## HISTORIC AND DESIGN REVIEW COMMISSION

**HDRC CASE NO:** 2016-063  
**ADDRESS:** 532 DAWSON ST  
417 N MESQUITE ST  
**LEGAL DESCRIPTION:** NCB 568 BLK 17 LOT E 2.08 FT OF N 107 FT OF 7 & N 107 FT OF 8  
NCB 568 BLK 17 LOT S 53 FT OF E 43 FT OF 8  
**ZONING:** RM4 H  
**CITY COUNCIL DIST.:** 2  
**DISTRICT:** Dignowity Hill Historic District  
**APPLICANT:** Logan Fullmer George Herrera  
**OWNER:** Logan Fullmer  
**TYPE OF WORK:** Conceptual approval of new construction of two detached multi-family units  
**REQUEST:**

The applicant is requesting conceptual approval to construct two, multi-family residential units at the corner of Dawson and N Mesquite.

## CONCEPTUAL DESIGN PROPOSAL

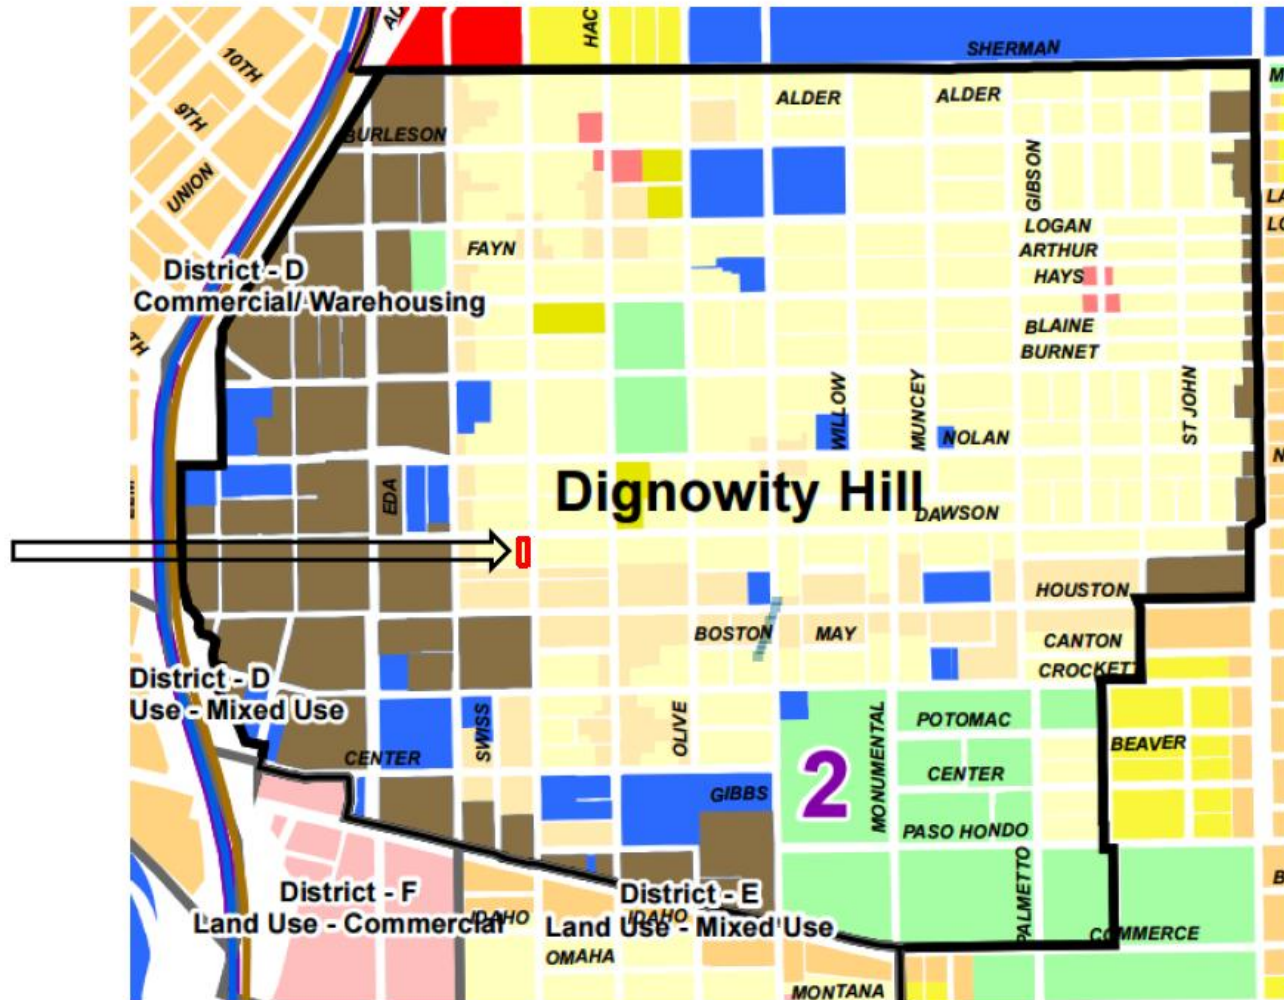
COMMENTS/CONCERNS: BF: QUESTIONS REGARDING PARKING -- HOW  
MANY ARE GARAGE / COVERED / OPEN -- CONCERNS OVER PARKING ON SITE  
CAUSING CLUTTER. MG: QUESTIONS REGARDING FOR SALE / RENTAL, SCALE  
IS STILL APPROPRIATE. RIBBON DRIVEWAY OFF OF DAWSON IS APPROPRIATE.

THE SCALE IS REASONABLE. AS: QUESTIONS REGARDING THE PRESERVATION  
OF TREES AND SITE FENCING. A LANDSCAPING PLAN WILL NEED TO BE  
PROVIDED. MG: ROOF GABLE ENDS ARE VERY PROMINENT NOW... DESIGN

MEETS THE DESIGN STANDARDS. BF: DESIGN W/ STEP DOWN OVER THE  
GARAGE IS MOST APPROPRIATE AND CONSIDERATE OF NEIGHBORS, THREE →  
COMMITTEE RECOMMENDATION: APPROVE [ ☒ ] DISAPPROVE [ ☐ ]  
APPROVE WITH COMMENTS/STIPULATIONS:

WINDOWS OVER TWO IS MOST APPROPRIATE FOR THE N MESQUITE FACADE.  
MG: POTENTIALLY ADJUST SITING OF 417 N MESQUITE TO PROVIDE MORE SPACE  
BETWEEN UNITS.
